SUBJECT: RESPONSE TO NRC 790117 TELCON REQUEST FOR ADDL INFO RE  
 QUESTIONS ON ANALYSIS IN SUPPORT OF 50% TUBE WASTAGE  
 PLUGGING LIMIT FOR STEAM GENERATOR TUBES.

H. B. ROBINSON STEAM ELECTRIC PLANT, UNIT NO. 2  
DOCKET NO. 50-261  
LICENSE NO. DPR-23  
STEAM GENERATOR TUBE PLUGGING CRITERIA QUESTIONS

Figure 1.  
Plastic Moment

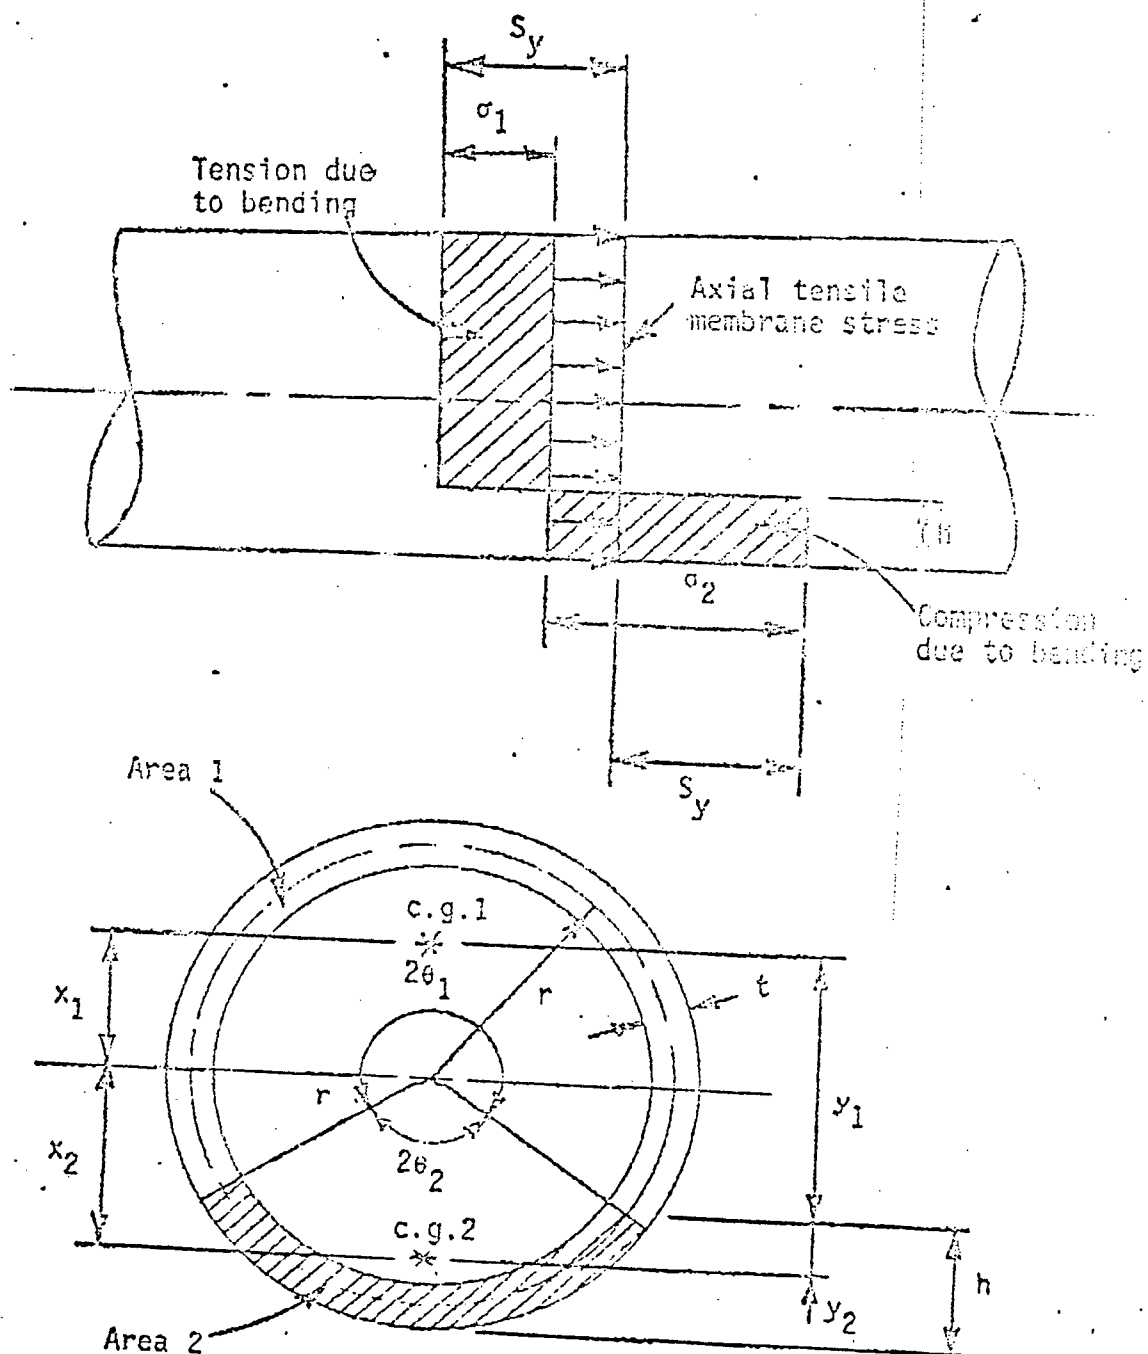
Question 1: On Page 2-12, it is stated that a limit analysis in accordance with rules of the ASME Code, Section III, Appendix F, has been performed. Indicate whether all the other requirements of F-1323.2 have been satisfied. Provide details of how the collapse loads, the LOCA loads (1568), and the SSE loads (407) were determined. Define  $M_p^*$ .

Answer: In this analysis: a) specified loads are less than 90 percent of the collapse load determined by lower bound limit analysis, b) the yield strength used equals 230 percent of the tabulated  $s_m$  value at 600°F. There was not any deformation limit specified in the E-Spec. Therefore, it is considered that all requirements of F-1323.2 are fully satisfied.

The collapse load is determined by the collapse moment.  $M_p$  is the collapse moment at a section without wall degradation.  $M_p^*$  is the collapse moment at a section with uniform tube wall degradation to .015". The collapse moments were calculated by considering combined bending and membrane action as follows: From Figure 1, it is clear that the tube area under tension (area 1) is different from the tube area under compression (area 2). The equilibrium condition dictates that  $\sigma_1 \times \text{area 1} = \sigma_2 \times \text{area 2}$ .

Since area 1 and area 2 are functions of  $\sigma_1$  and  $\sigma_2$ ,  $\sigma_1$  and  $\sigma_2$  were computed by first calculating the axial tensile membrane stress and then calculating  $\sigma_1$  and  $\sigma_2$ , i.e.,

After  $\sigma_1$  and  $\sigma_2$  were determined,  $x_1$ ,  $x_2$ ,  $y_1$ , and  $y_2$  were calculated.

The collapse moment  $M_p$  or  $M_p^*$  was finally calculated by using the relation,

Figure 3. Simply Supported LOCA Tube Model

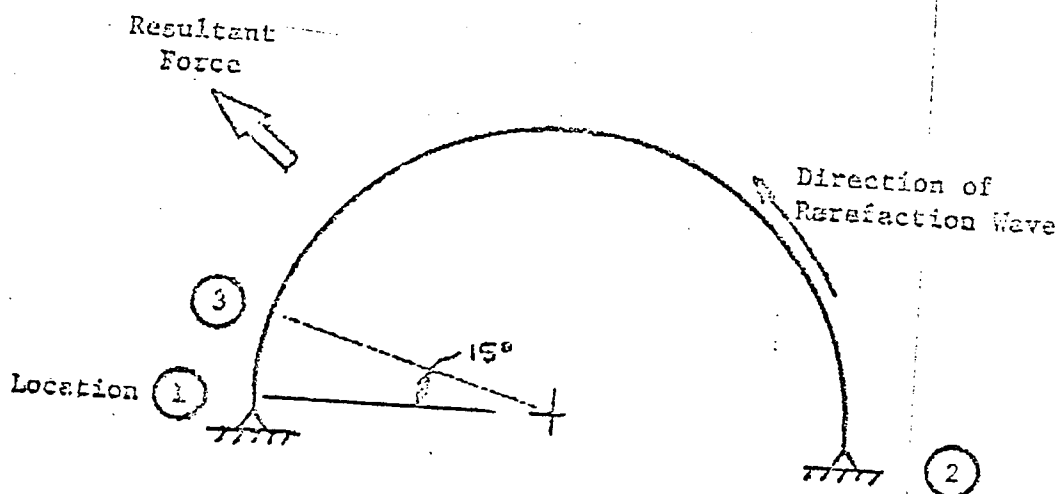
Question 2: Provide the justification for selecting value of  $\theta_3$  used in the moment calculations. Provide details of the analyses done that result in the moment curves shown in Figure 2-6, e.g., where the LOCA and SSE analyses performed assuming pinned connections at the top support plate?

The LOCA loads were calculated by employing a dynamic finite element computer code, SAP4. A finite element model of the U-tube was constructed and the LOCA rarefaction wave pressure history was input. The U-tube was modelled as a continuously supported tube (Figure 2) and a simply supported tube (Figure 3). With the simply supported tube, the maximum bending moment during the transient occurs at location 3 (see Figure 3). This maximum moment was labelled as  $M_{\text{LOCA}}$ .

Since the seismic model employed a U-tube continuously supported at tube support plate locations,  $M_{\text{SSE}}$  was computed by multiplying  $M$  by the ratio of the moment at location 3 (see Figures 2 and 3) from the simply supported semi-circular tube LOCA run and the continuously supported U-tube LOCA run.

Answer: The angle  $\theta_3$  was selected because the moment calculated by SAP4 is a maximum at  $\theta_3 = 150^\circ$  as shown in Figure 3. The moment curves shown in Figure 2-6 for LOCA and SSE conform to the fundamental mode (an antisymmetrical mode) of the tube and are verified by the output from
